Technical Service Information

THM 3T40 (125C) 1-2 ACCUMULATOR PISTON AND SEAL CHANGE

Figure 1

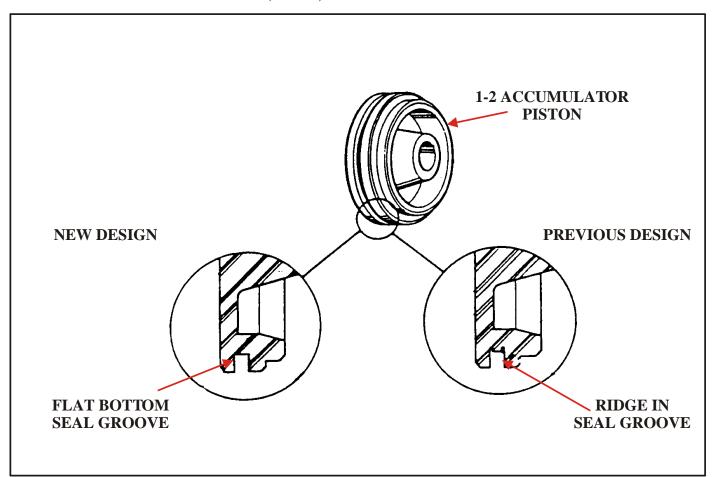
CHANGE: The 1-2 accumulator seal has been changed from solid Teflon seal to a lathe cut rubber seal,

which also required a new design 1-2 accumulator piston (See Figure 1)

REASON: Reduced leakage in accumulator.

: (1) 1-2 Accumulator Piston - New design piston that has a flat bottom seal groove

instead of a ridge in the bottom of the seal groove (See Figure 1).

(2) 1-2 Accumulator Piston Seal - Now lathe cut rubber seal instead of Teflon.

The new 1-2 accumulator piston and seal can be used on all previous models as a complete assembly. The new lathe cut rubber seal CANNOT be used on the previous design piston. Do not attempt to mix these parts.
